Technical Service Bulletin: tsb100163

Released Date: 31-May-2002

QSX15 CASE Specific Software Announcement

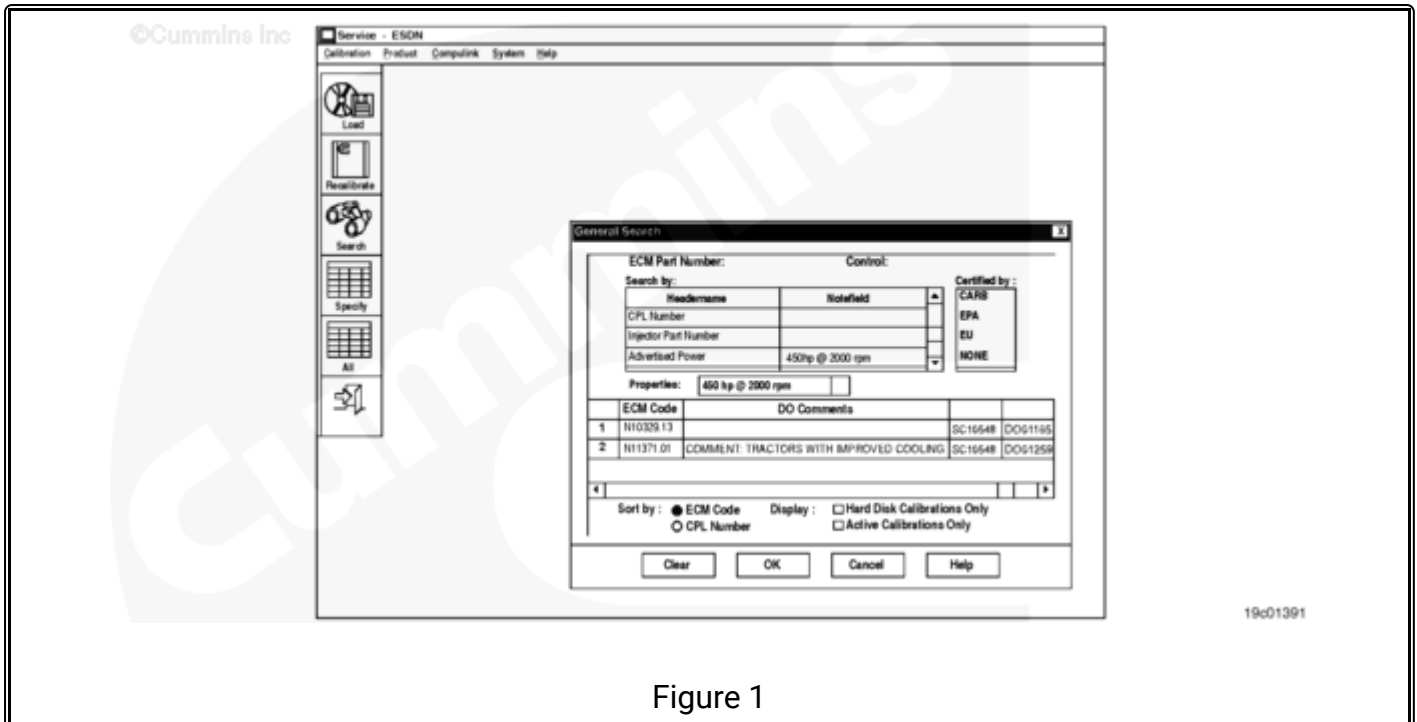
For the May 2002 ESDN INCAL CD-ROM, the engine serial number first (ESNF) for the new CAC became known, so the comment fields will read as follows; Before ESN 14027676 or After ESN 14027676 (see Figure 2).

Note : If DO 1165 is installed in engines built after 14027676, the benefit of the improved CAC will be lost, but the intake manifold temperature will be maintained at an acceptable level to maintain Tier II emissions standards.

Note : If DO 1269 is installed in engines built before 14027676, the intake manifold temperature could exceed the maximum allowable temperature and possibly jeopardize compliance of Tier II emission standards. Do not use DO 1269 in engines built prior to ESN 14027676.

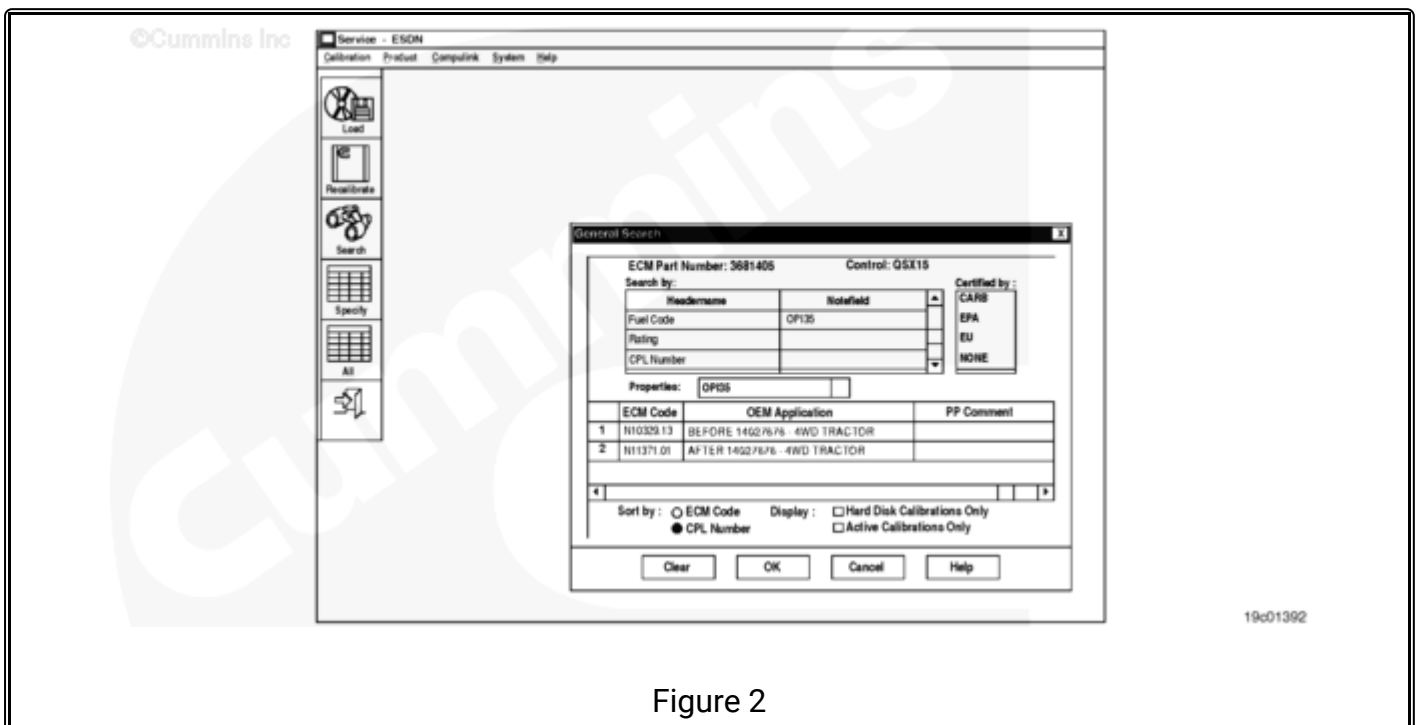
The original Tier II QSX15 450 HP for CNH used Customer Interface Software option DO 1165. The new DO option for use with the improved CAC is DO 1259. When selecting the calibration for a STX 450 or TJ 450 tractor, the DO comment field will guide the user to the correct calibration. Specifically, the April 2002 ESDN INCAL CD will have the following note in the DO 1259 comment field: COMMENT: TRACTORS WITH IMPROVED COOLING SYSTEM (see Figure 1).
